Interactive comment on “Development of a statistical tool for the estimation of riverbank erosion probability” by E. A. Varouchakis et al.

Received and published: 3 October 2015

Fig. 1. Methodology flowchart that presents the combined application of the BSTEM and of the proposed statistical model (SMODEL) based on LR principles.

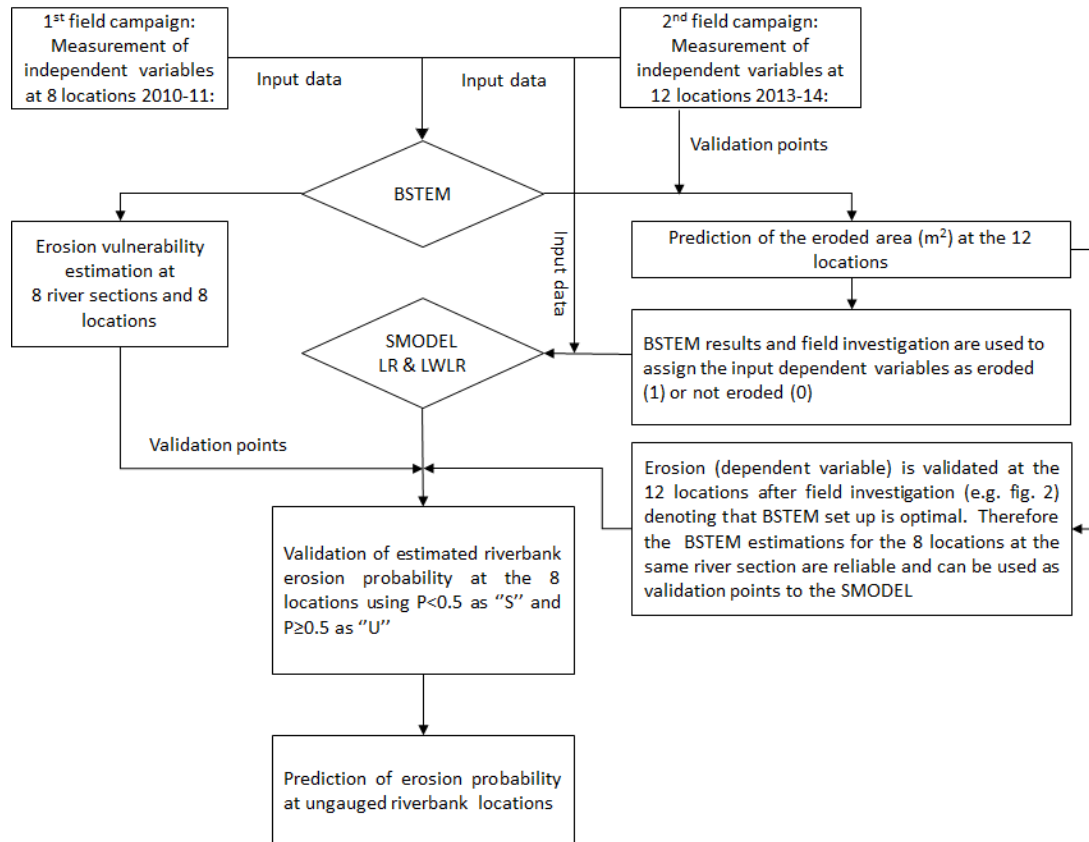
2) My own area of expertise regards bank erosion, and here I have major concerns that lead me to recommending major revision. The paper does not show any validation of the method by showing a comparison between predicted bank erosion and observed bank erosion. No maps of erosion predictions are given.

We have included a methodology flowchart that fully explains the approach followed accompanied by a characteristic photo highlight of the riverbank location (KI) with the most intense observed erosion. Regarding the BSTEM model validation for the predicted erosion (m^2), a field investigation was performed at the end of the wet season of the 2013-14 hydrologic year. Photographs were taken at some locations where the 50 cm scaled stick was placed showing the eroded area. The eroded area at each location was successfully predicted as the observed affected area was quite similar. Especially, at location (KI) with the most significant effect, the predicted eroded area (using BSTEM) was equal to 2.043 m^2 and the affected area measured at the field (and represented in the modified photo) was roughly 2.08 m^2 . Similar results were obtained for the other locations. However, as the purpose of this work was to use BSTEM results (at the 12 locations) in accordance with the field inspection to setup the statistical model and to provide validation points, quantified measurements at those points were not performed but, field inspection was used to validate that the BSTEM results are consistent and close to reality. Therefore, only at the point with the most intense erosion a close photo was taken and analysed to quantify the erosion.

Fig 1. Methodology flowchart that presents the combined application of the BSTEM and of the proposed statistical model (SMODEL) based on LR principles.

The methodology flowchart (Fig. 1), the photo (Fig. 2) and the above text will be added appropriately in the final manuscript.

Fig. 3. Erosion probability predictions considering the 8 validation points using LR (a), LWLR with exponential (b) and tricubic (c) weighting function vs independent variables at ungauged riverbank locations

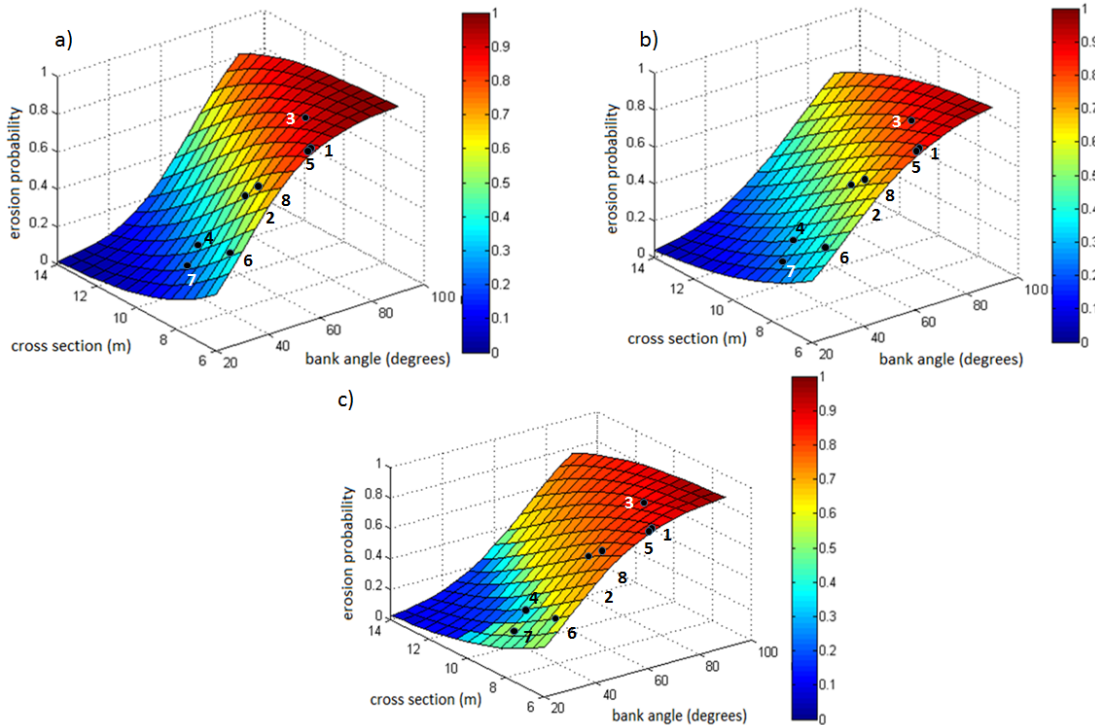
4) Three out of the five figures show predictions for three different regression methods without possibility of comparison with data or inter-comparison.

Inter-Comparison of estimations is possible as the x and y axis of the plots are at the same scale for the results of the three methods tested and specific discussion is available in page 660 lines 15-26. In addition, we have added the validation point predictions on the plots for easier inter-comparison (Fig. 3 a,b,c below corresponds to Figs. 3,4,5 of the submitted manuscript). Comparison with data is not possible as the model predicts probability of presence or absence of erosion at unmeasured locations. The plots present the probability of bank erosion to occur (z axis) for a specific couple of secondary variables (x and y axes). The model’s accuracy has been tested as previously described.

Fig 3. Erosion probability predictions using LR (a), LWLR with the exponential weighting function (b) and LWLR with the tri-cubic weighting function (c) versus independent variables at ungauged Koiliaris’ riverbank locations. The black dots indicate the 8 validation points.
